ICHD - ENVIRONMENTAL HEALTH DIVISION

SEPTIC: IMPROVEMENT PERMIT / AUTHORIZATION TO CONSTRUCT / OPERATION PERMIT / EXISTING SYSTEM

PERMIT # AP 326525

SOIL/SITE EVALUATION
for ON-SITE WASTEWATER SYSTEM

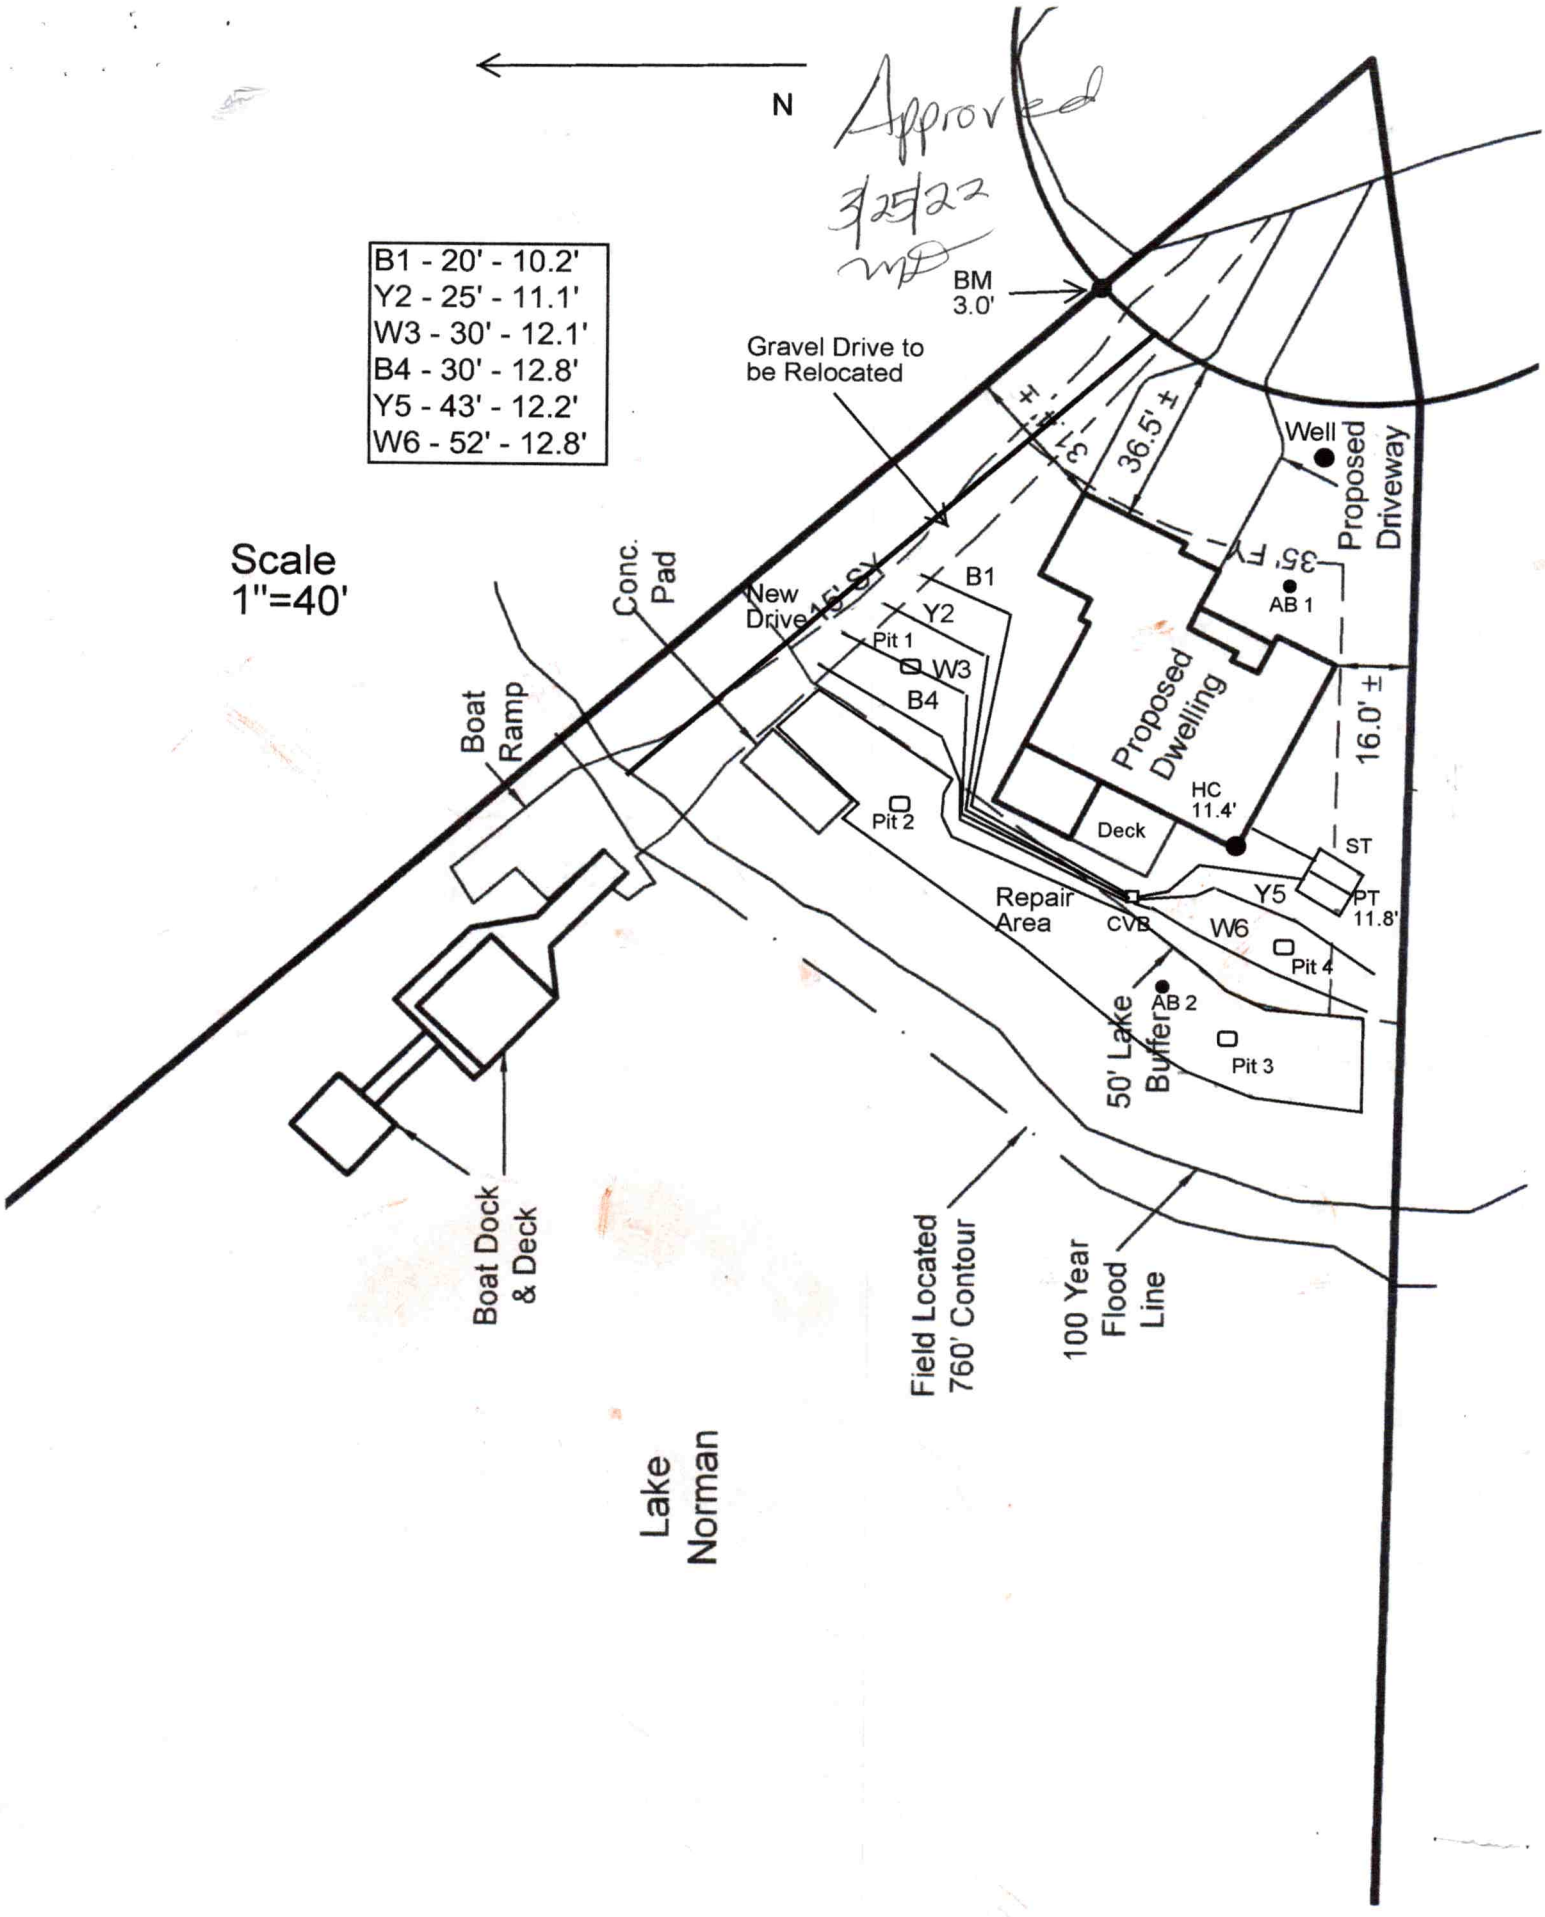
* these two lines were dug 6/16/23 – sand laid in trenches but no product. Ditches were backfilled (due to rain) w/o product. 6/19 Sand was varying depths (8"–4") in W6 trench, highside was 26" at max. → when trenches are re-excavated they MUST not exceed 26" at any point, sand must be properly distributed

See attached notes - trench may not exceed 26" max

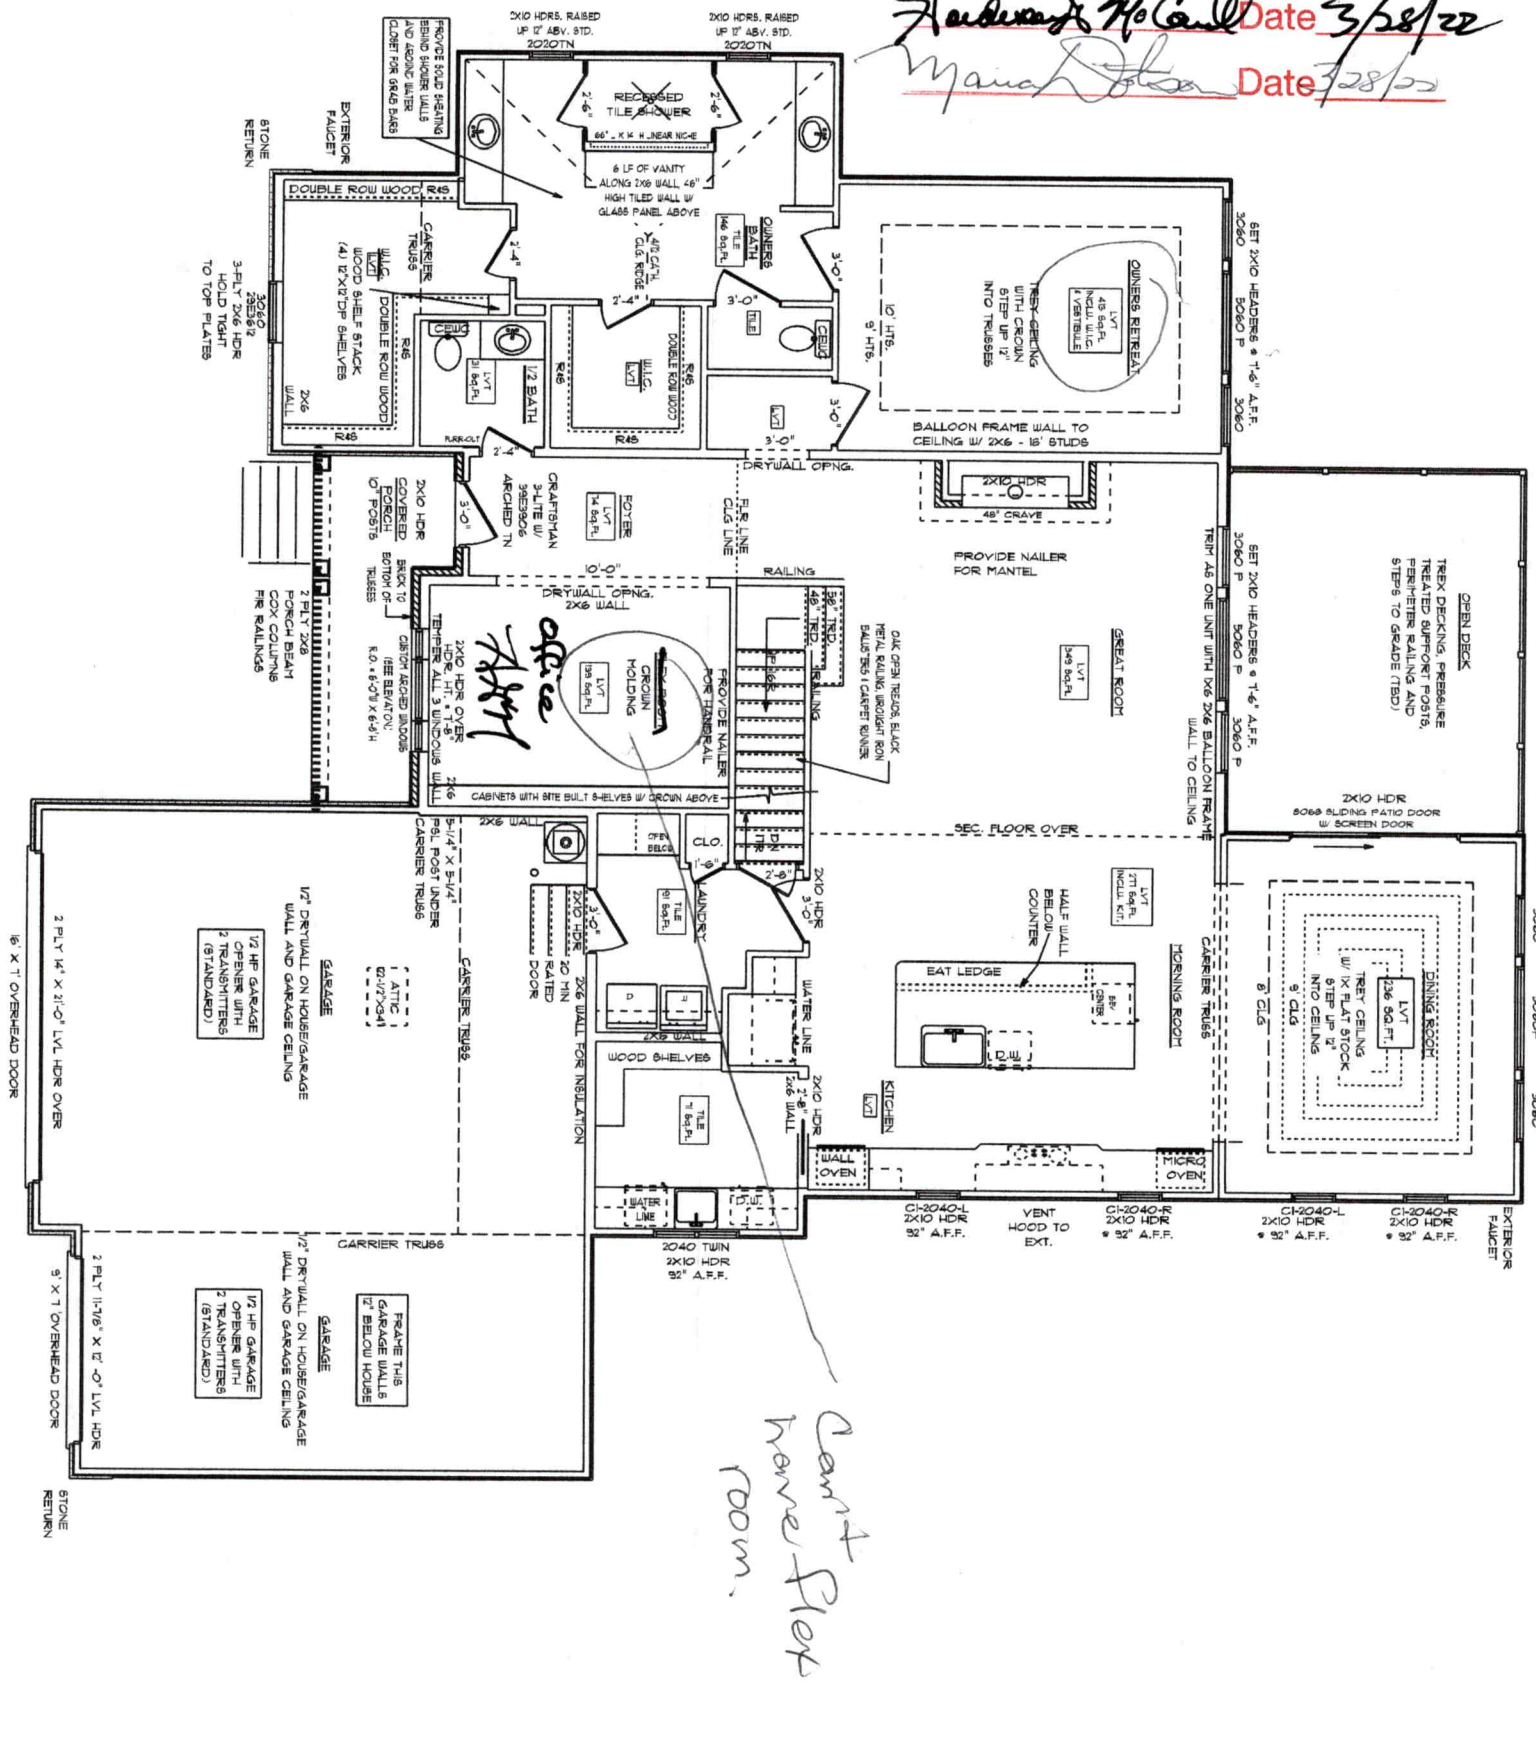
Can't have flex room.
